# UNITED STATES PATENT AND TRADEMARK OFFICE

10/591,645

Katsuya Okumura

<b>Office Action Summary</b>	<b>Application No.</b> 10/591,645	<b>Applicant(s)</b> OKUMURA ET AL.	
	<b>Examiner</b> JOSHUA BENITEZ	<b>Art Unit</b> 2829

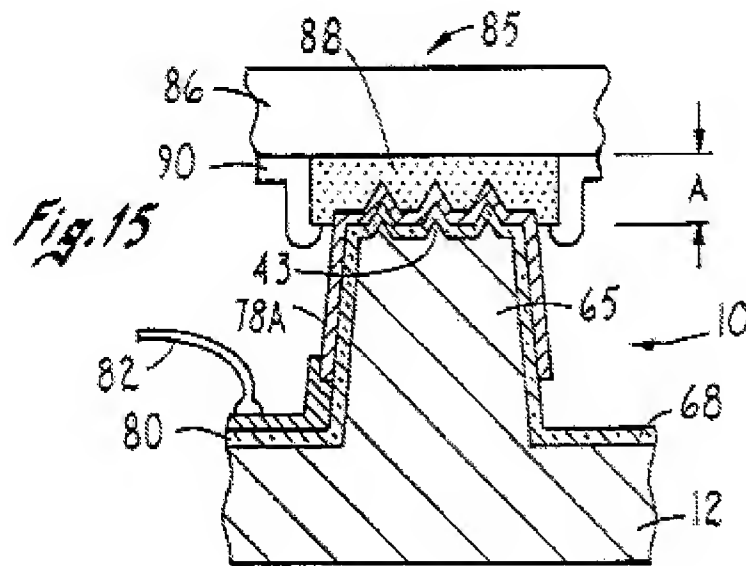
Claim 1 is rejected under 35 U.S.C. 102(b) as being anticipated by Akram et al (U.S. Patent No. 5,483,741).

In re claim 1, Akram '741 discloses in figure 15 a probe (10) that comes into electrical contact with an object to be inspected (85) when inspecting an electrical characteristic of the object to be inspected (85), the probe comprising:

a probe main body (65) having a contact portion that comes into contact with the object to be inspected (85);

a plurality of conductive materials (projections of element 43) each having a tip portion projecting from the contact portion of said probe main body (65),

wherein the contact portion has a contact surface (62) that comes into contact with the object to be inspected, the tip portions are formed to project from the contact surface, a projection length of the tip portions being larger than a thickness of an oxide film formed on a surface of an electrode (88) of the object to be inspected (85), and the

contact surface is formed substantially parallel to the surface of the electrode and comes into contact with the oxide film on the surface of the electrode to function as a stopper for the tip portions when the tip portions penetrate the oxide film to reach the electrode (col. 8, lines 53-67).
